GALWAY CITY COUNCIL

OLD DUBLIN ROAD - NEW LAWN CEMETERY

STAGE F PART 2 ROAD SAFETY AUDIT

June 2023

Figure 2-1 Proximity of Entrance to R338 Junction (Extract Dwg No. 11614-1002-D00)

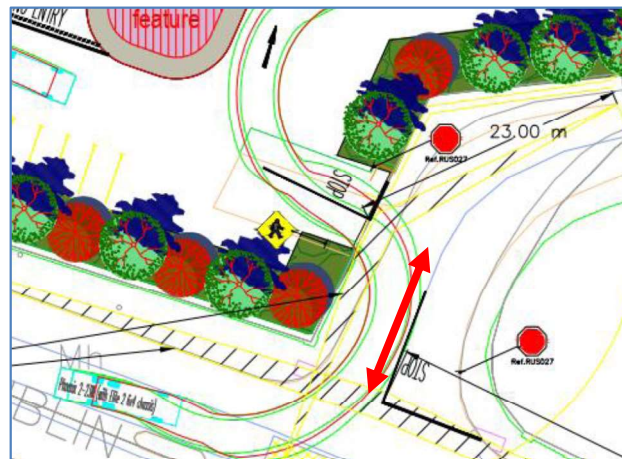
Proximity of Proposed Entrance to R338 Junction

The Audit Team are concerned about the proximity of the proposed entrance to the junction on the R338. The distance from a vehicle turning off the mainline (from either direction) to a vehicle departing the entrance / queue of vehicle entering the new entrance, may result in sideswipe / rear-end collision.

The design team should site the entrance a suitable distance from the R338 to allow for vehicle reactions times.

Figure 2-2 Pedestrian Desire Line from Connaught Hotel to Galway City (Extract Dwg No. 11614-1002-D00)

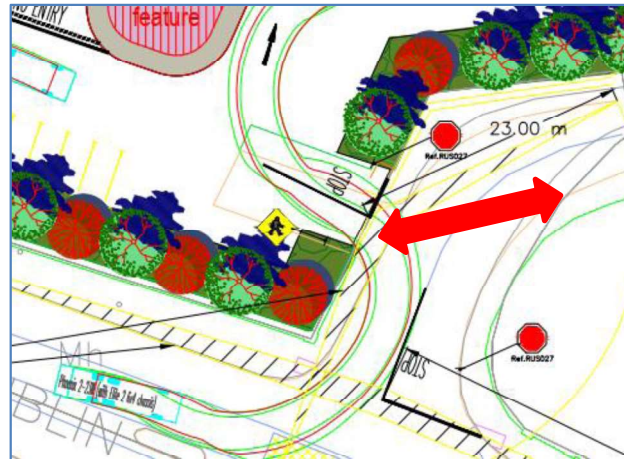
Pedestrian Desire Line – Connaught Hotel

It was observed onsite a number of pedestrians departing the Connaught Hotel in the direction of Galway City, crossing diagonally in front of the new entrance to the development. The Audit Team are concerned that the lack of pedestrian provisions on northwest side of the proposed entrance will result in a continuation of this existing pedestrian pattern. The introduction of the entrance will present a hazard to these vulnerable road users (VRUs).

The design team should provide a suitable crossing / continuous footway from the Connaught Hotel across the entrance along the desire line.
